SNF-7000
Revision 0

Multi-Canister Overpack Handling Machine - Independent Review of Seismic Structural Analysis

Project No: W-379
C. E. Swenson
FH

TS
 Sheet No. 5 of
 Job No. F2S66

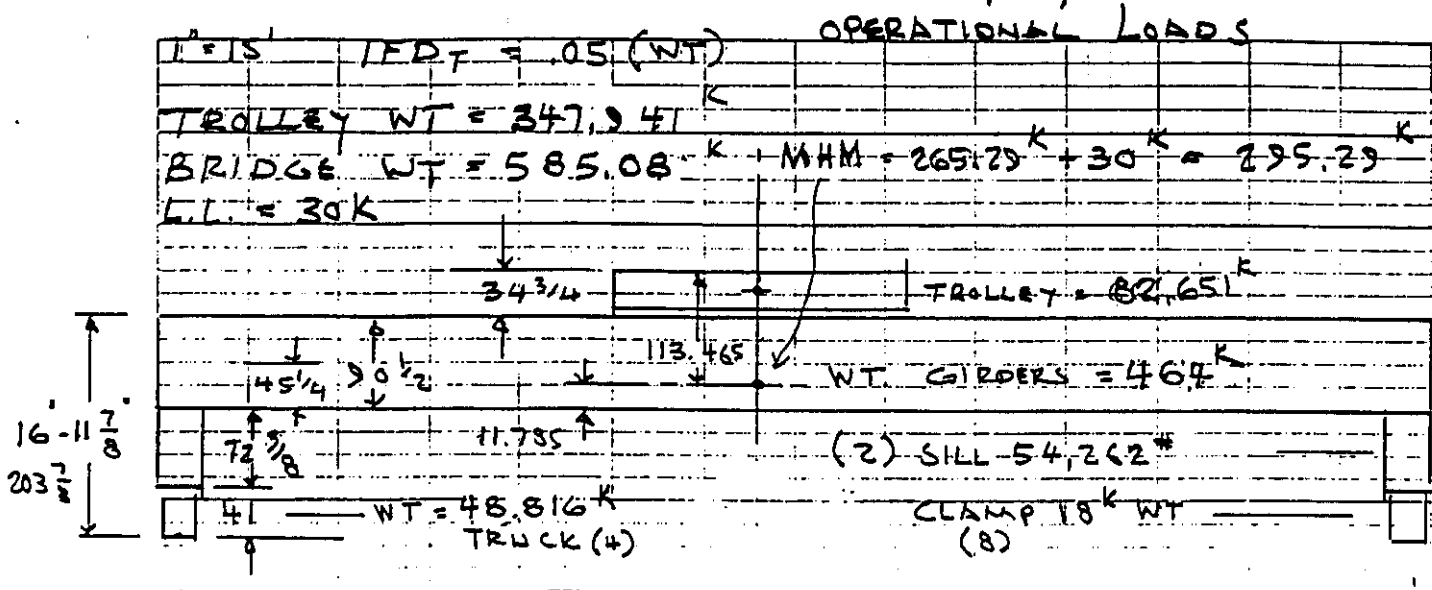
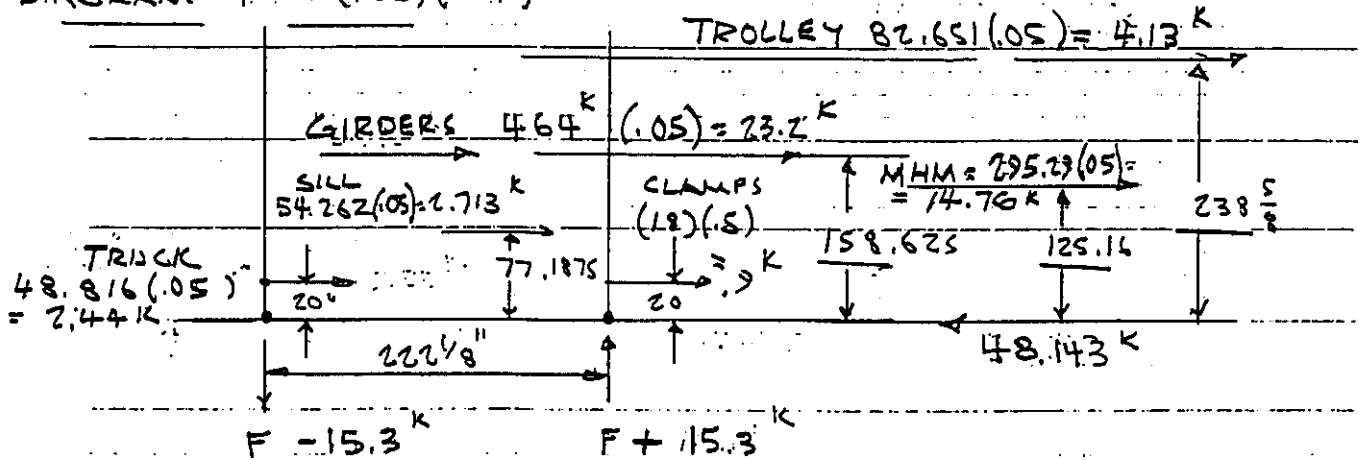
Item 2a Section B Sheet TS5

Sheet No. L-4 of
 Job No. F-2666

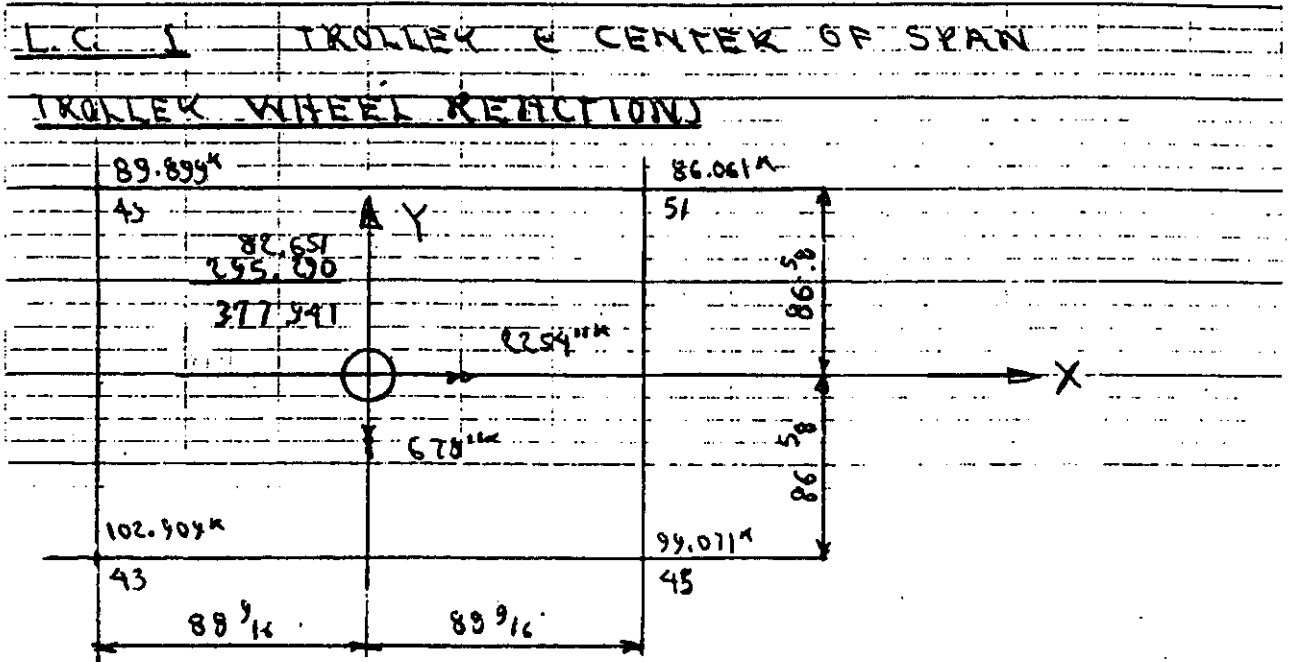
Comment: Section C Sheet L-4 Py load should be Pz loads.

△ Ref ET 24 & ET 25

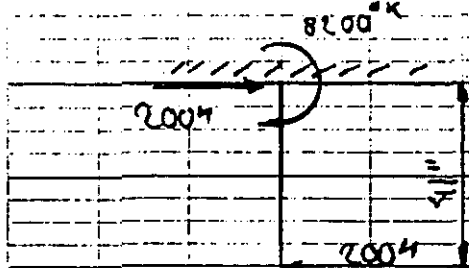
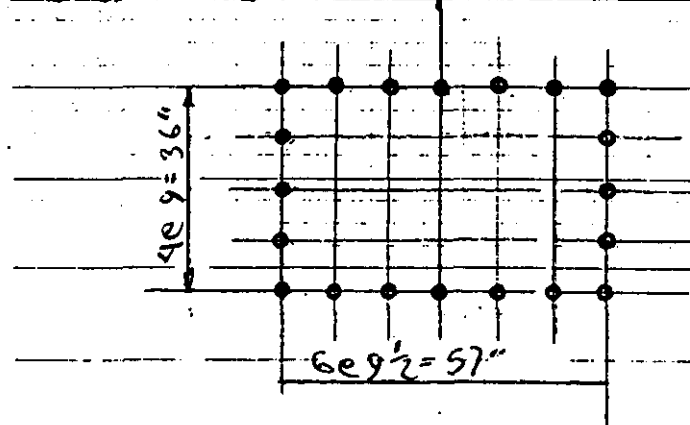
Comment: Sheet SG22 Reference should be made to Sheets ET24 and ET25.

STS
 Sheet No. 2 of
 Job No. F2566

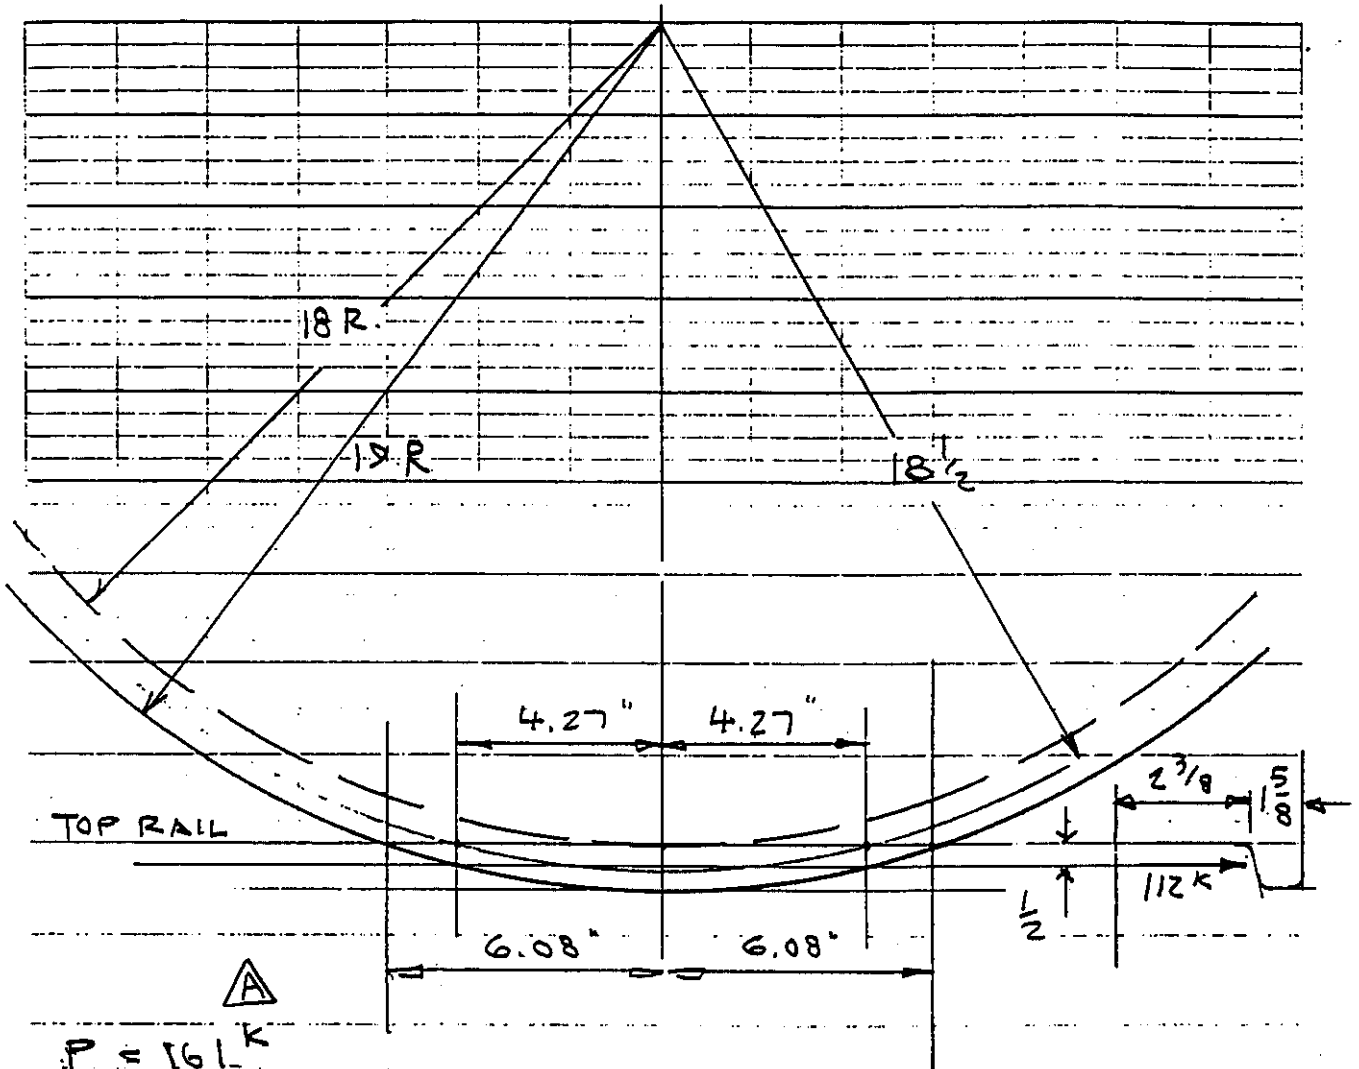
4	<p>Sheet STS2: This Table D2, is different than Table D2 in the GEC-Alsthom Report ESL/R(96)083, rev.2, dated October 1997, which we have in our possession. (The difference in the Trolley Quarter Span Loads. We believe this to be a correct Table, however we wonder why Table D2 and others in the GECA report are not.) We do not have these corrected(?) Tables A2 through E2 and cannot verify if Table D2 loads are governing.</p>

Comment: Sheet ST52. This table D2 is different than Table D2 in the GECA report.

Reply: Sheet ST52 is the correct table.
